SECTION 75W ARCHITECTURAL DESIGN STATEMENT

Macquarie Park Station Waterloo Road

Architectural Design Statement\_Section 75W S10758 February 2018

# 4.9 S75W ADJUSTMENTS SCHEME COMPARISON PARK

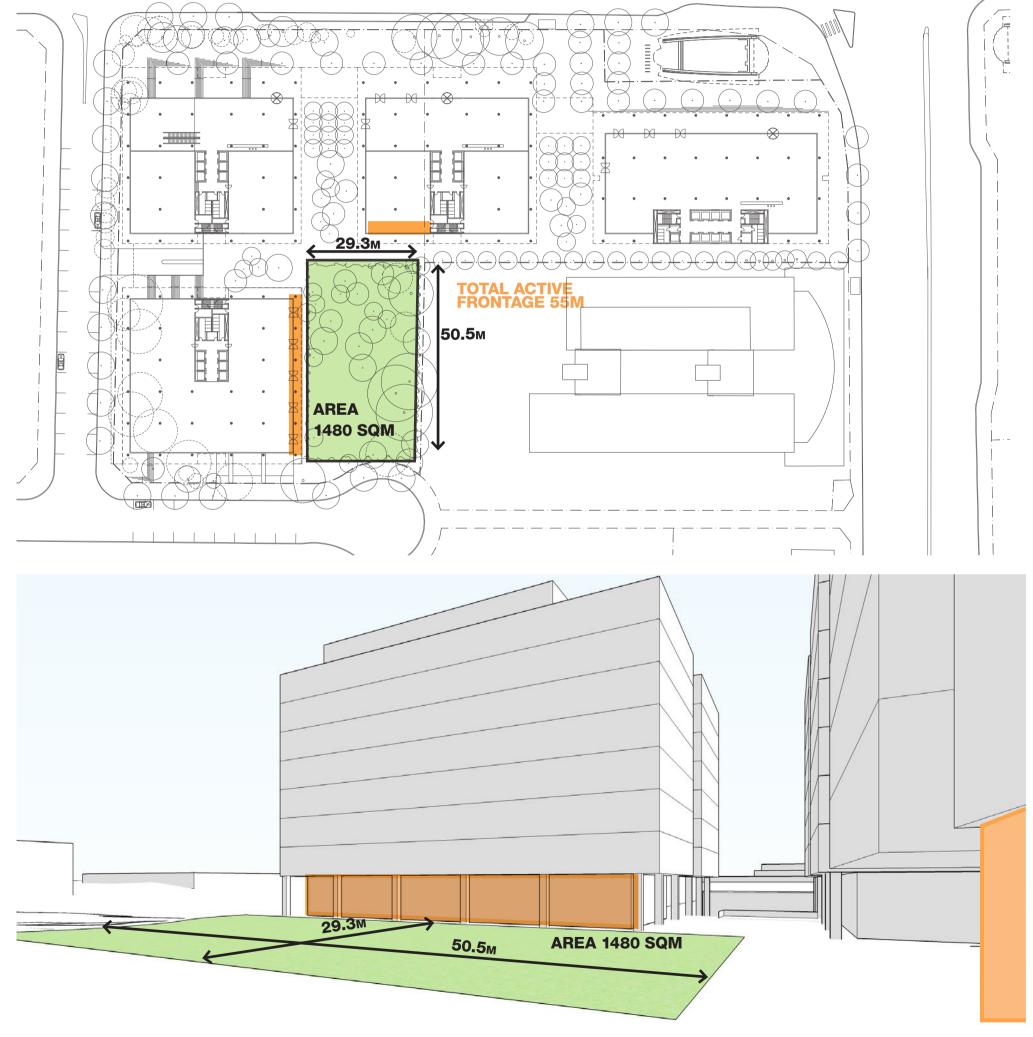
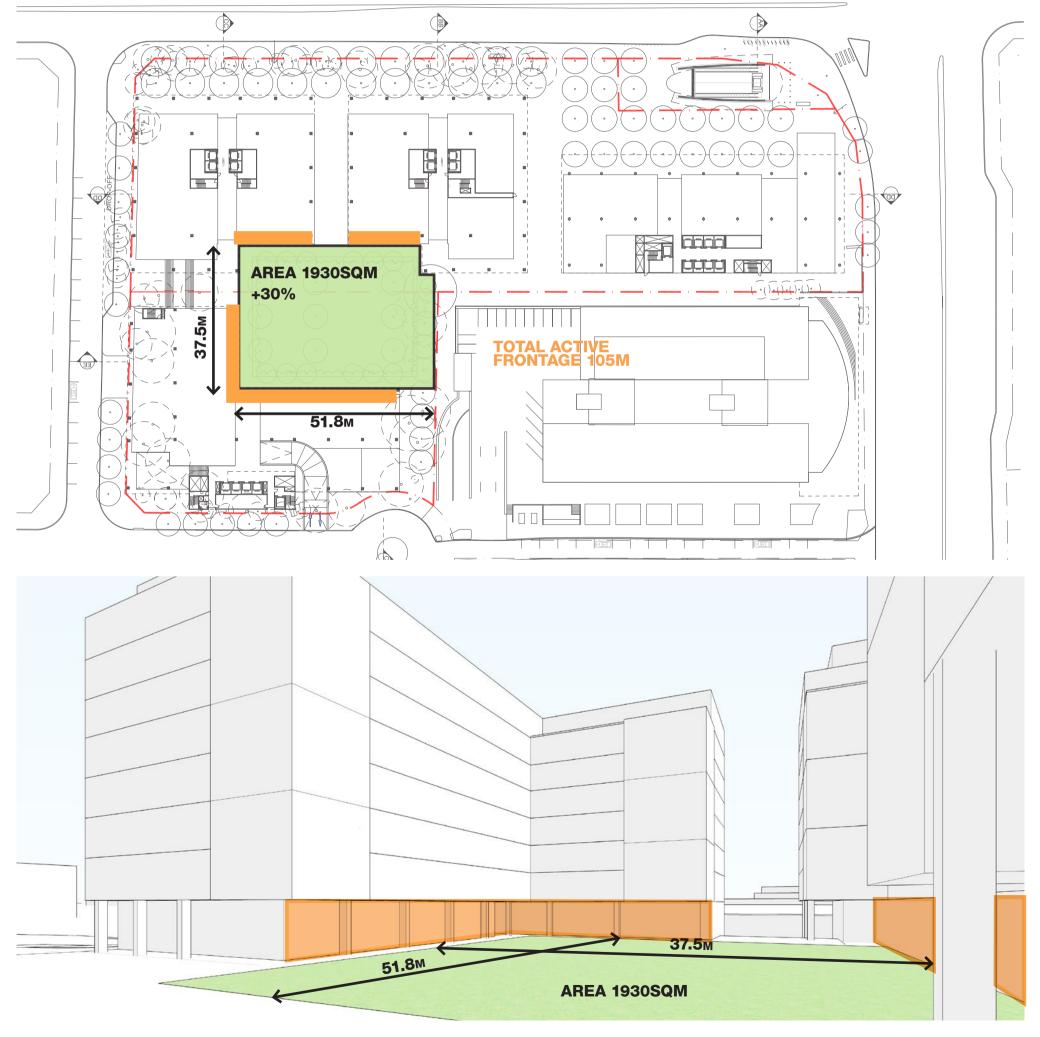
The following diagrams describe the amendments and improvements to the central park in the Section 75W submission

The park has increased by 30% to be 1,930sqm (an increase of 450sqm).

In addition to the size, the proportion and location has been amended to create significant increase in park frontage (50% increase) to achieve more retail activation at ground level and improve passive surveillance.\

As describe in this later in the report, the daylight access is also improved with the alterations to the building footprints. As a result more daylight access is achieved to improve the amenity and usability of the park.

# 4.11 S75W ADJUSTMENTS PUBLIC BENEFIT IMPROVEMENTS

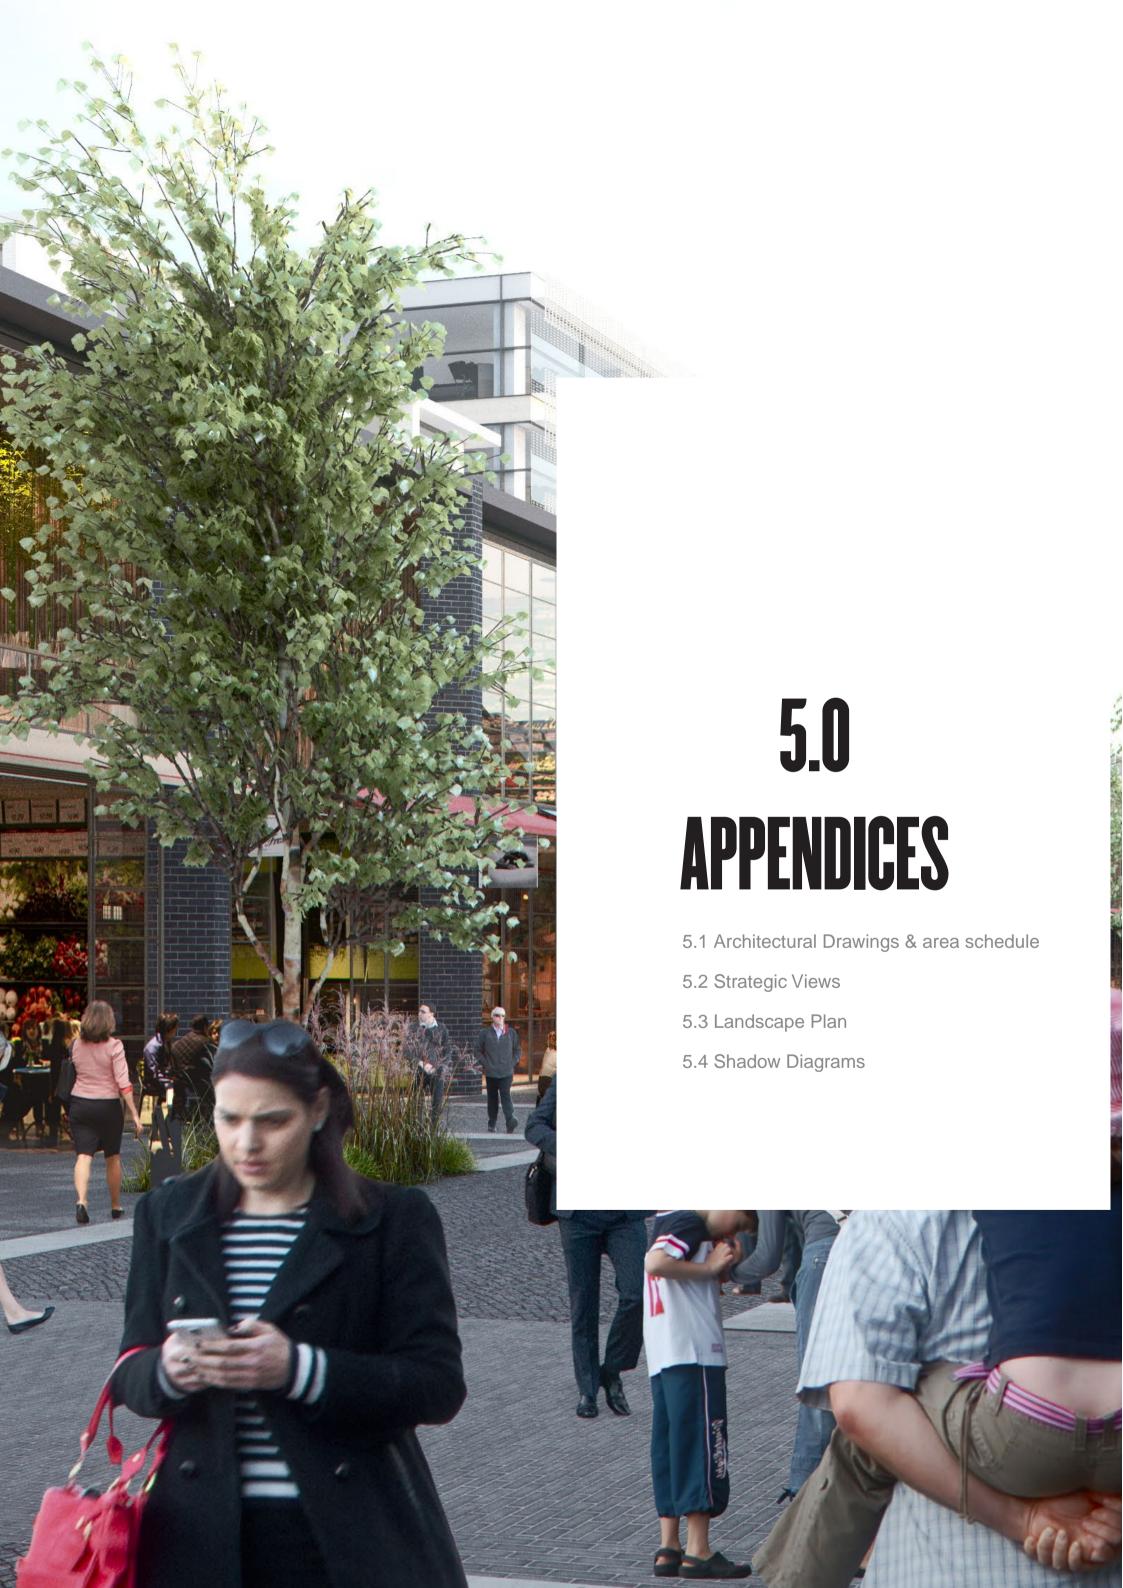
- a. Improved activation through vibrant, retail laneway strategy
- b. Increased size of Station Plaza
- c. Increased size of Waterloo Rd Plaza
- d. Wider separation at Coolinga Street entry without a vehicle cross-over
- e. Larger park size
- f. Increased visibility of park from surrounding streets
- g. Increased daylight access to park
- h. Activated park via retail frontages
- i. Pedestrian-focused precinct
